ATTACHMENT 6

Page 13 of the Appeal Resolution Document accompanying the September 26, 2000 Preliminary Map

Figure 2. Dike Sections Conducive to Piping Failure

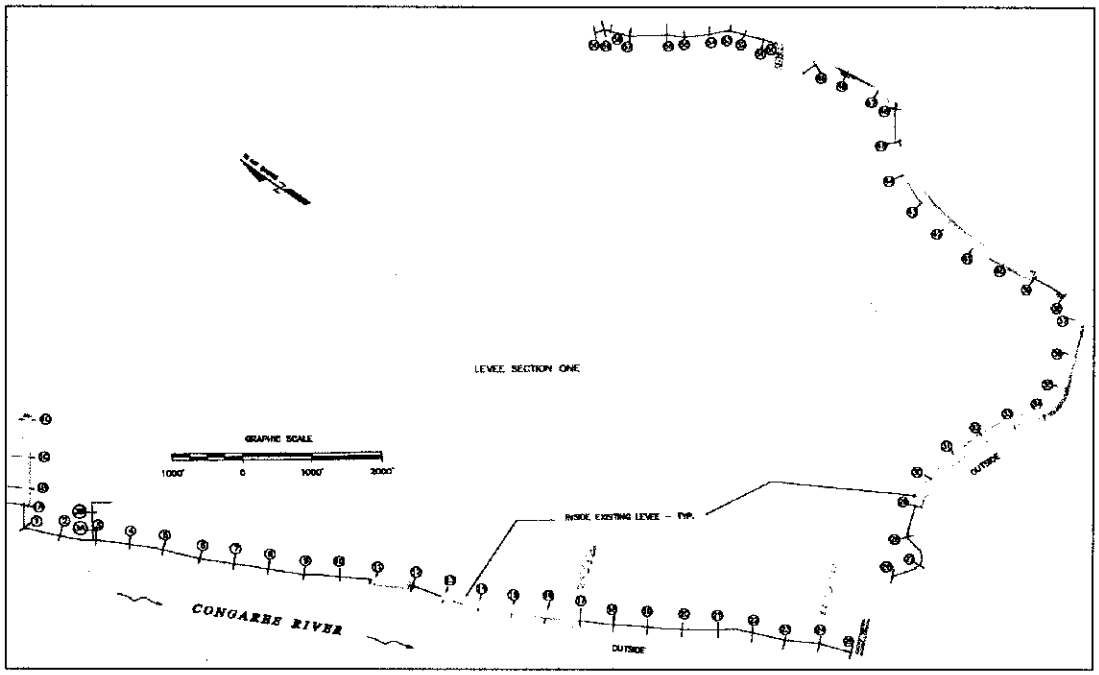
The second question was answered by considering the breaches that occurred in 1976, and considering the ratio of hydraulic head across the levee to the base width of the levee, H/L. In 1976, one breach had a width of 110 feet, while another had a width of 95 feet. The H/L ratios for a 100-year flood would be greater than those experienced in 1976. Based on the relative H/L ratio and extensive engineering experience, it was determined that a breach would likely be about 120 feet wide.

The third question was answered by analogy to the 1976 flood. Based on the experience of the two failures in 1976, it would be reasonable to assume that the levee could fail by piping at two or possibly three weak locations during a single occurrence of the 100-year flood.
